SERVICE BULLETIN

PURPOSE : INFORMATION	ISSUE NO. : MSB-12EXL00-005	DATE : 2012-07-13
SUBJECT : INFORMATION ON 2013 PAJERO SPORT/NATIVA/MONTERO SPORT/CHALLENGER		<Destination/Model> (G.EXP/GCC/THAI/MMAL/NZ/RUSSIA/MEXICO) "KH8W" <M/Y> 13
GROUP : GENERAL

This Service Bulletin contains the information about the 2013 PAJERO SPORT/NATIVA/MONTERO SPORT/CHALLENGER Body Repair Manual.

FENDER SHIELD

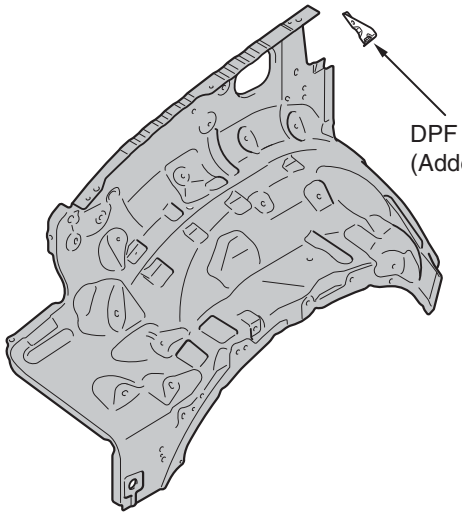
The section "FENDER SHIELD" and ''SILENCER APPLICATION LOCATIONS'' below have been changed.

Due to the addition of models conforming to emission standard Euro5, a DPF pipe bracket has been added.

DASH PANEL

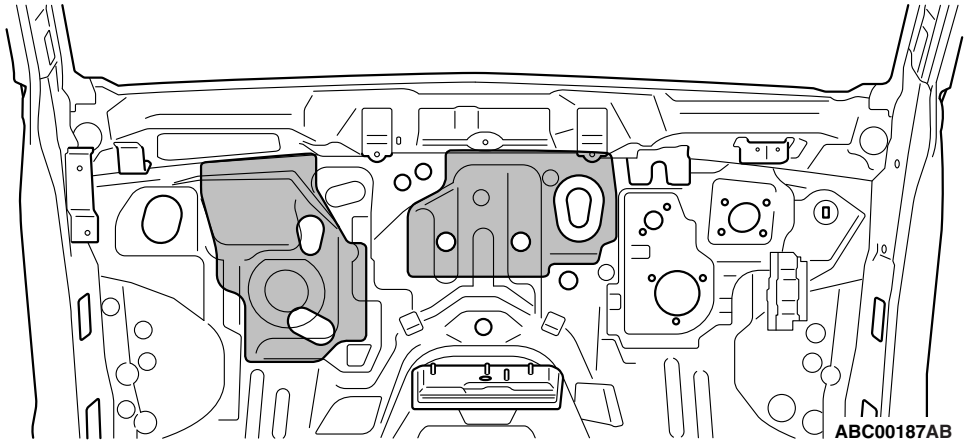
In order to suppress noise, a silencer (melting sheet) has been adhered on the dash panel.<Vehicles for Australia and New Zealand (option)>

: 2.0 mm thick melting sheet (Place two melting sheet one on top of another.)

( ) indicates the number of 1.6 mm thick melting sheets that are used for repair.
